FINAL DRAINAGE PLAN

THE RIDGE AT LORSON RANCH

JANUARY, 2022

Summary of Comments on Microsoft Word - 100.064-pdr

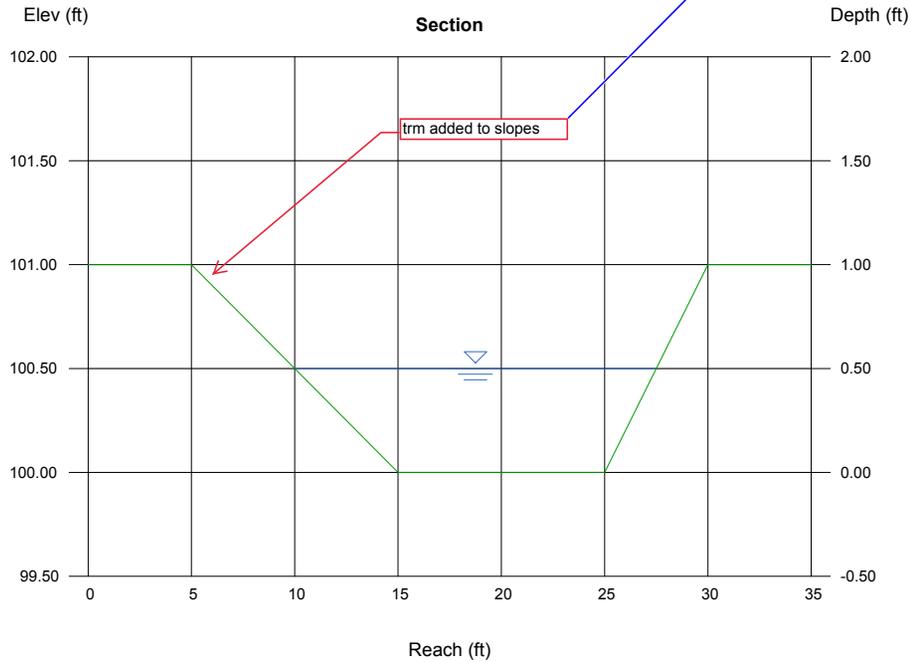
Include design information for TRM

Author: RSchindler Subject: Sticky Note Date: 3/10/2022 8:59:19 AM -06'00'
type of TRM added

Author: RSchindler Subject: Callout Date: 11/5/2021 11:54:20 AM
trm added to slopes

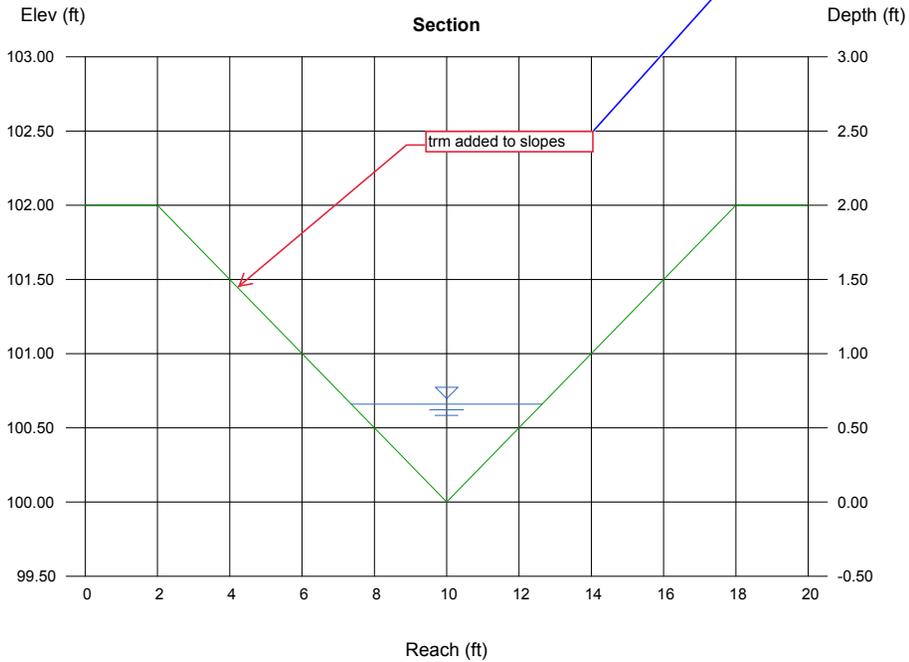
Include design information for TRM

Author: RSchindler Subject: Sticky Note Date: 3/10/2022 8:59:33 AM -06'00'
 type of TRM added

Author: RSchindler Subject: Callout Date: 11/5/2021 11:54:31 AM
 trm added to slopes

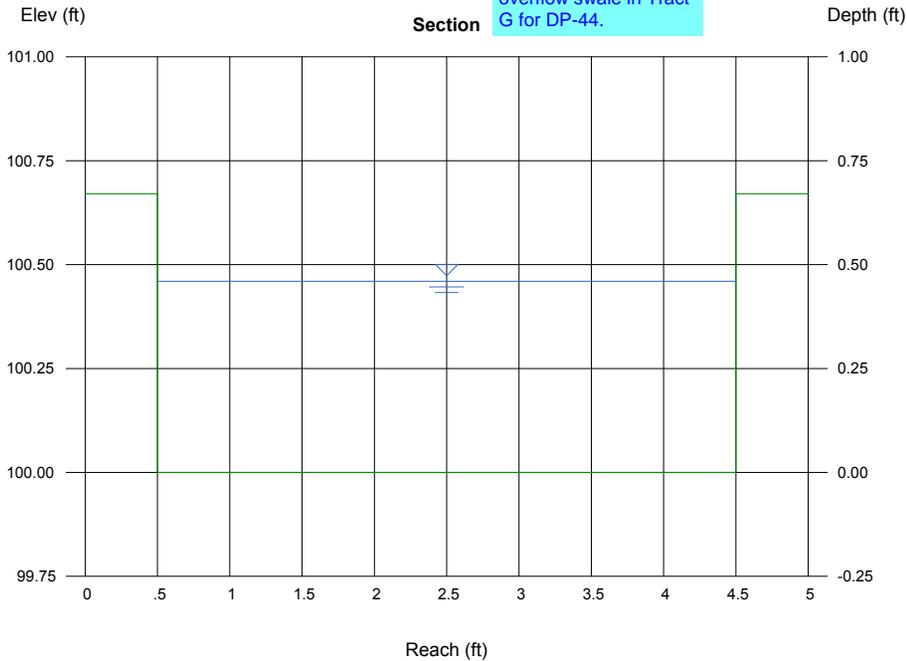
Include calculation to size riprap for spreader.

not needed. spreader reduced flows to non-erosive velocities. we added small rock for additional protection.

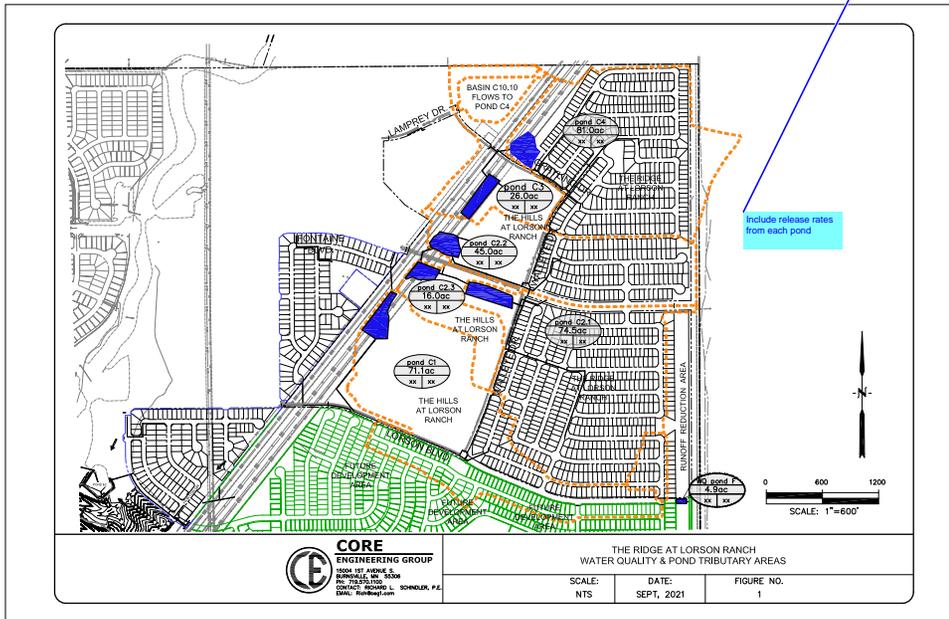
Please include spreadsheet/table listing contributing basins and % impervious to each pond.

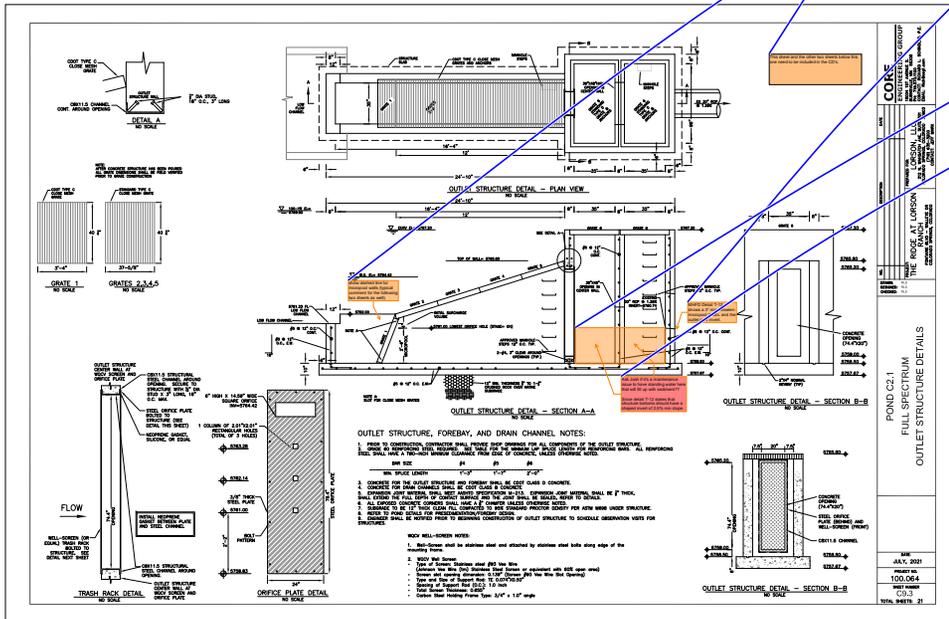
Please include calculation for low flow channel in Pond & riprap sizing for spillway

Author: Glenn Reese - EPC Stormwater Subject: SW - Textbox Date: 2/22/2022 9:07:18 PM -06'00'
 This sheet and the other two sheets below this one need to be included in the CD's.

Author: Glenn Reese - EPC Stormwater Subject: SW - Textbox with Arrow Date: 2/22/2022 9:08:48 PM -06'00'
 show dashed line for micropool walls (typical comment for the following two sheets as well).

Author: Glenn Reese - EPC Stormwater Subject: SW - Textbox with Arrow Date: 2/23/2022 3:23:48 PM -06'00'
 MHFD Detail T-12 shows a 3" min between micropool WSEL and the outlet pipe invert.

Author: Glenn Reese - EPC Stormwater Subject: SW - Textbox with Arrow Date: 2/23/2022 3:21:09 PM -06'00'
 Ask Josh if it's a maintenance issue to have standing water here that will fill up with sediment?? Since detail T-12 states that structure bottoms should have a shaped invert of 2.5% min slope.

Author: RSchindler Subject: Sticky Note Date: 3/10/2022 2:02:08 PM -06'00'
 these structures are in the early grading plan and are built.

Author: RSchindler Subject: Sticky Note Date: 3/10/2022 2:01:03 PM -06'00'
 this structure is built with early grading.

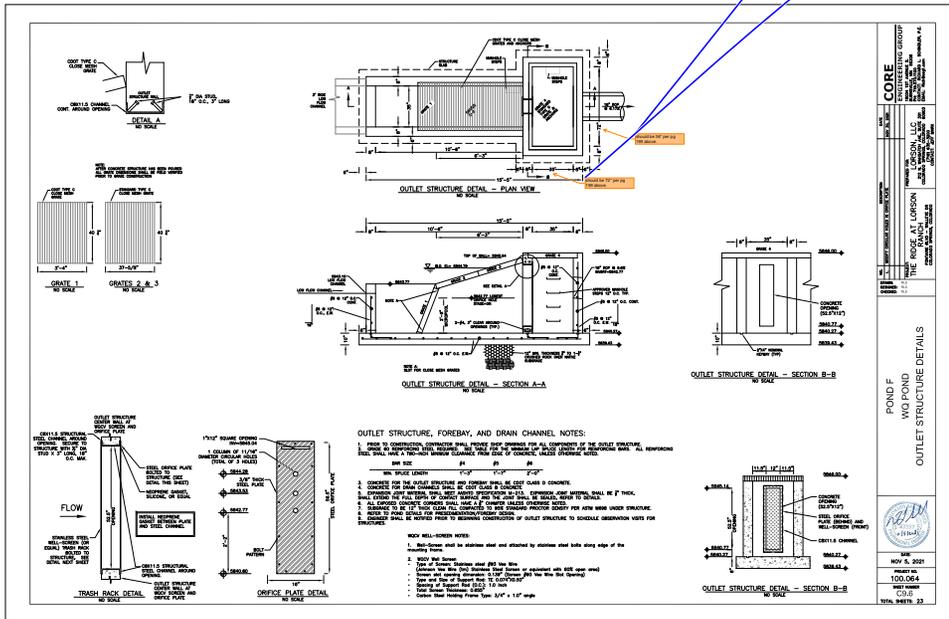
should be 36" per pg 199 above.

Author: RSchindler Subject: Sticky Note Date: 3/10/2022 2:17:46 PM -06'00'
the size is correct. we just juxtaposed length/width which does not change design.

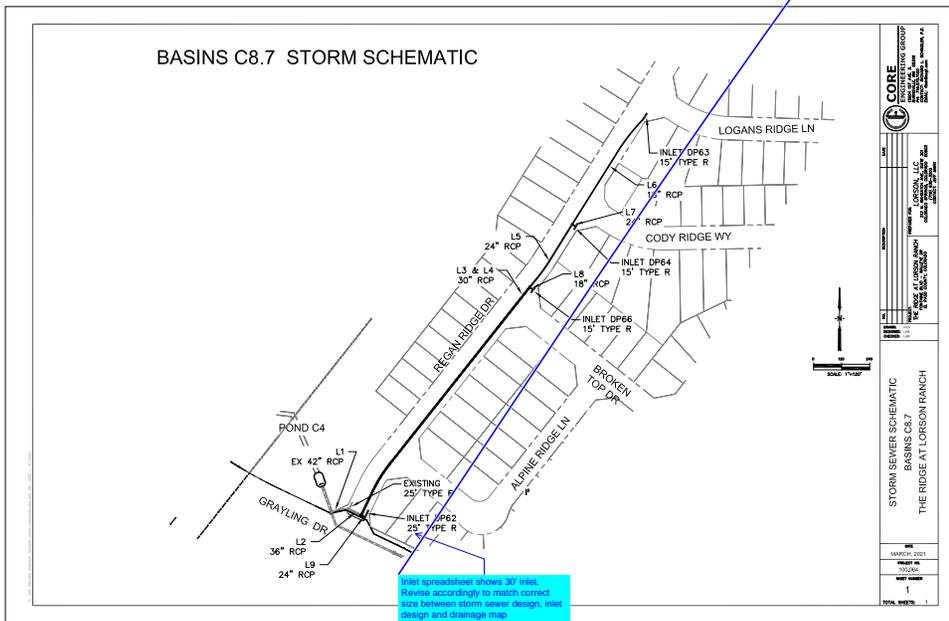
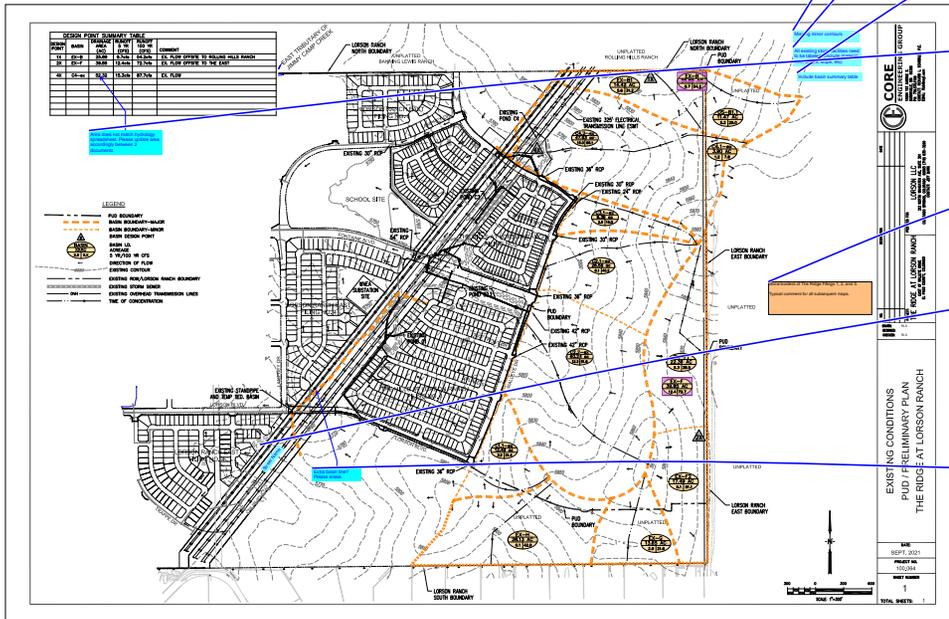
Update storm sewer calculations as flows at proposed inlets may have changed

Author: RSchindler Subject: Sticky Note Date: 3/10/2022 2:18:29 PM -06'00'
flows updated

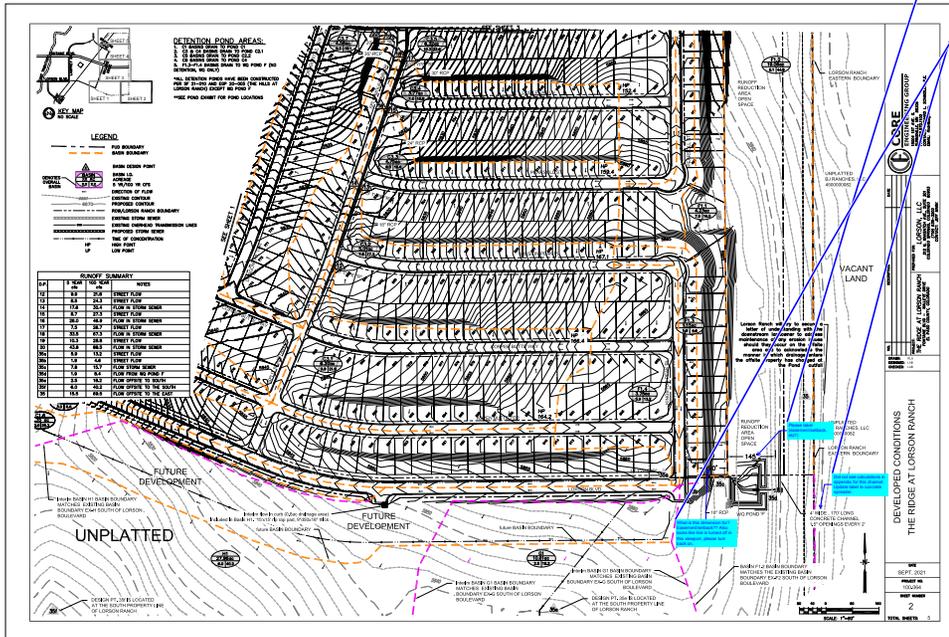
Please label (easement/setback, etc?)
- Author: RSchindler Subject: Sticky Note Date: 3/11/2022 7:28:47 AM -06'00'

Did not see calculations in appendix for this channel. Update label to concrete spreader.
- Author: RSchindler Subject: Sticky Note Date: 3/11/2022 7:37:02 AM -06'00'

RUNOFF REDUCTION DIMENSION
- Author: CDurham Subject: Callout Date: 2/17/2022 4:36:32 PM -06'00'

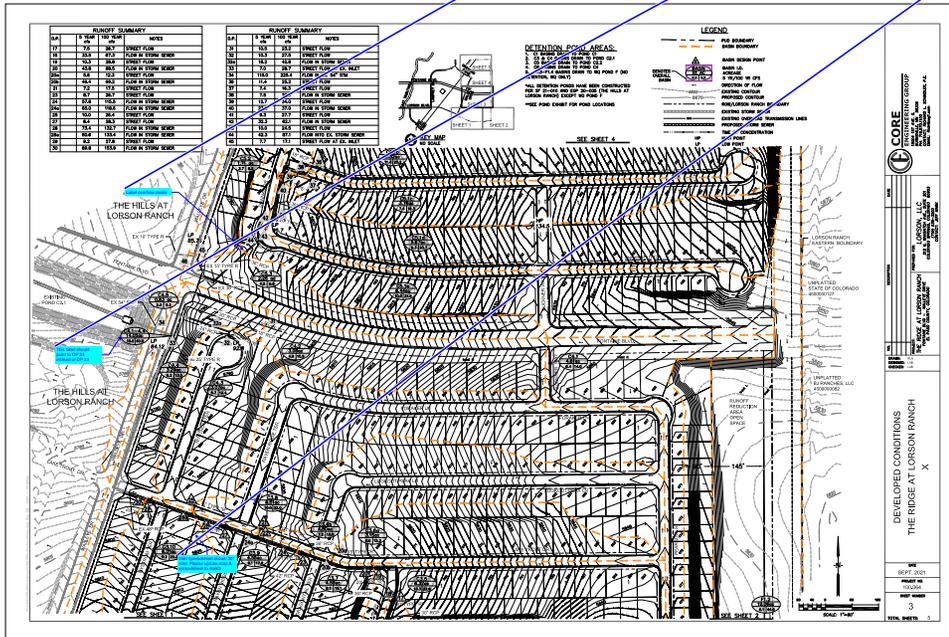
Author: CDurham Subject: Callout Date: 2/17/2022 4:37:04 PM -06'00'
Label overflow swale

Author: RSchindler Subject: Sticky Note Date: 3/11/2022 7:40:58 AM -06'00'
SWALE LABELED
